SUNDRY NOTICES AND REPORTS ON WELLS
Do not use this form for proposals to drill or to re-enter an abandoned well. Use form 3160-3 (APD) for such proposals.

8. Well Name and No.
DIAMOND 5 FED 03 ✓

9. API Well No.
30-025-29729-00-S1 ✓

EOG Resources proposes to P&A this well as follows:

Diamond 5 Fed #3

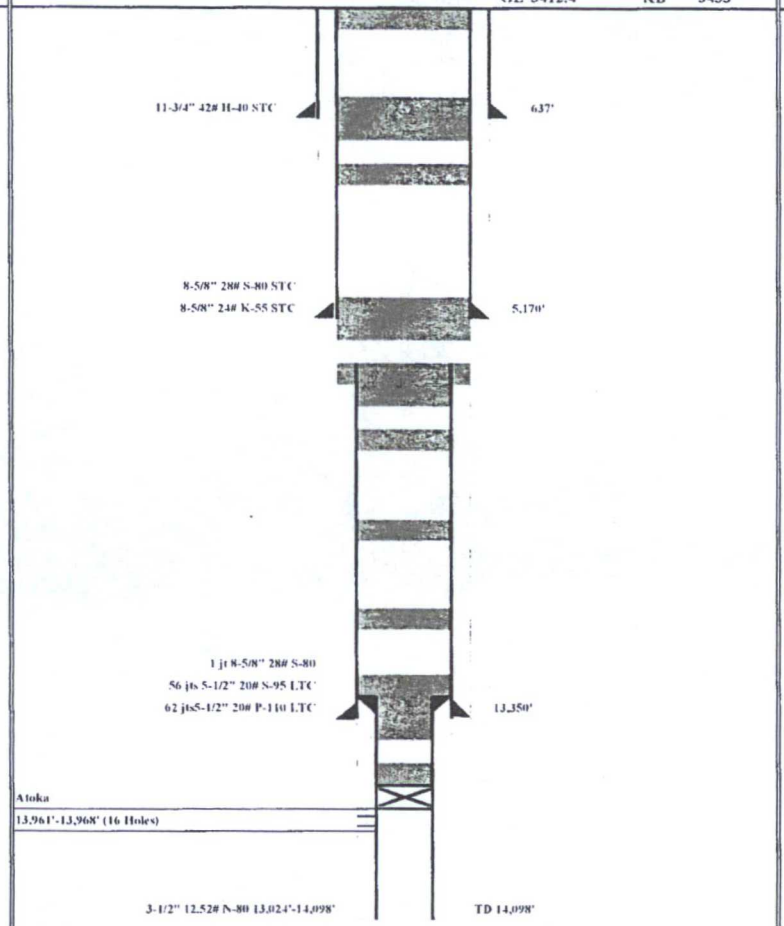
1. Set 3-1/2" CIBP at 13860'. Dump bail 35' of Class H cement on CIBP.
2. Circulate wellbore with 9 ppg mud. Continue to add mud to keep wellbore full
3. Spot 60 sx Class H cement plug at 13450'. WOC and TAG. Tag at 12974 or higher
4. Spot 35 sx Class H cement plug at 12420'. WOC and TAG. Tag at 12200 or higher
5. Spot 25 sx Class H cement plug at 9257'. WOC and TAG. Tag at 9067' or higher
6. Spot 25 sx Class H cement plug at 6300'. - 6140'
7. Cut and pull 5-1/2" casing from +/- 5750'.
8. Spot 40 sx Class C cement plug at 5800' or 50' inside casing stub, WOC and TAG. Tag @ 5640 or higher
9. Spot 40 sx Class C cement plug at 5270'. WOC and TAG. Tag at 5120 or higher
10. Spot 45 sx Class C cement plug at ~~1540~~ 1650-1540' (TOS @ 1600') WOC and TAG.

**** BLM REVISED ** BLM REVISED ** BLM REVISED ** BLM REVISED ** BLM REVISED ****

Formation Tops	Hole	AFE #
		Spot +/-10sx Class C from 60' to surface
	17-1/2"	TOC @ Surface
		Spot 50sx Class C @ 687', TAG @ 587'
		Spot 45sx Class C @ 1,540', TAG @ 1,340' (TOS @ 1600') 1650 1540
5,254 Delaware	12-1/4"	Spot 40sx Class C @ 5,270', TAG @ 5,120'
		Cut and pull 5-1/2" csg @ +/- 5,750'
6,244 Cherry Canyon		Spot 40sx Class C @ 5,800', TAG @ 5,640'
		Spot 25sx Class H @ 6,300' -6140
9,207 Bone Spring		TAG @ 9,067'
		Spot 25sx Class H @ 9,257'
12,320 Wolfcamp		TAG @ 12,200'
		Spot 35sx Class H @ 12,420'
		TAG @ 12,974'
	8-3/4"	TOL @ 13,024
		Spot 60sx Class H @ 13,450'
13,670 Strawn		Bail 35' Class H on CIBP
		CIBP @ 13,860'
13,818' Atoka	6-1/8"
